DEVELOPMENT APPLICATION ASSESSMENT REPORT

Application Number:	DA2024/0492
---------------------	-------------

Responsible Officer:	Thomas Prosser
Land to be developed (Address):	Lot 1 DP 524083, 21 A Warili Road FRENCHS FOREST NSW 2086 Lot 1 DP 1298188, 49 Blackbutts Road FRENCHS FOREST NSW 2086
Proposed Development:	Neighbourhood title subdivision comprising of 13 lots and new road access
Zoning:	Warringah LEP2011 - Land zoned R2 Low Density Residential
Development Permissible:	Yes
Existing Use Rights:	No
Consent Authority:	Northern Beaches Council
Delegation Level:	DDP
Land and Environment Court Action:	No
Applicant:	Sekisui House Services (NSW) Pty Limited

11. Amendments to the approved plans

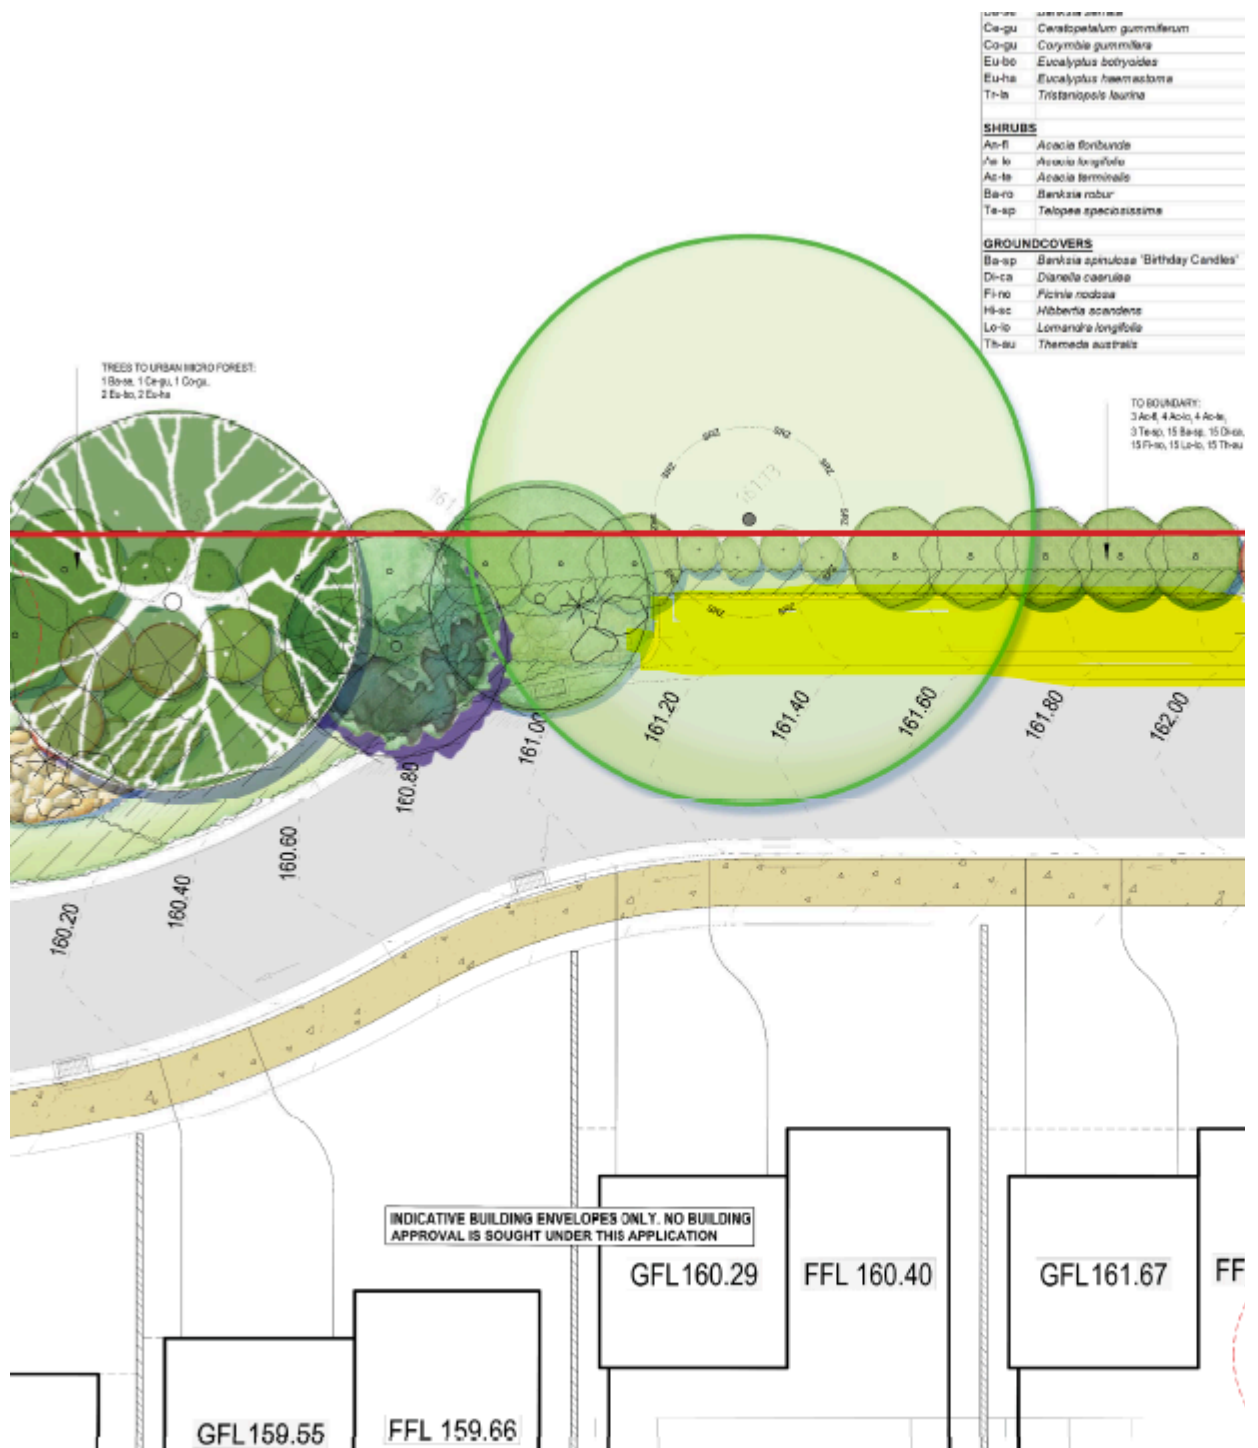
- The three on-street car parking spaces to the south (highlighted in yellow below) are to be deleted and replaced with landscaping with proposed planting extended.
